Recall Bulletin

PRODUCT SAFETY RECALL

SUBJECT: Transfer Case – Inspect / Replace

MODELS: 2008 Chevrolet 1500 AWD Express
2008 GMC 1500 AWD Savana

2170234

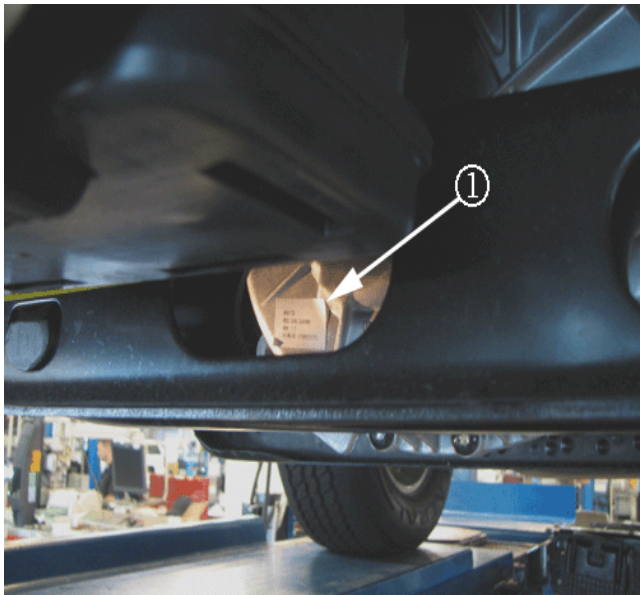
2. Locate and inspect the transfer case date sticker. The transfer case date sticker is located on the back of the transfer case (1) near the left (driver side) front of the torsion bar mounting bracket.
 - 2.1. If the date code, located on the second line of the sticker, indicates **06/18/2008 or 06/20/2008**, continue to Step 3 and replace the transfer case.
 - 2.2. If the date code is **not** 06/18/2008 or 6/20/2008, the transfer case is okay. No further action is required.
3. If the inspection determines that a transfer case replacement is required, contact the Product Quality Center (PQC) and request a transfer case. The full 17-character VIN, the

date code from the transfer case date sticker, and the 08244 bulletin reference number will be required when ordering.

4. Refer to SI and replace the transfer case. All removed transfer cases should be held until a Warranty Parts Center (WPC) request for return is received. **DO NOT SHIP WITHOUT AN OFFICIAL WPC REQUEST.** If you do not receive a WPC Request, contact Annette Quince at 248-371-9939 (for French call the PQC at 1-866-654-7654).
5. Return the removed transfer case to the WPC following the procedures outlined in bulletin 99-00-89-019E, including the draining of fluids.
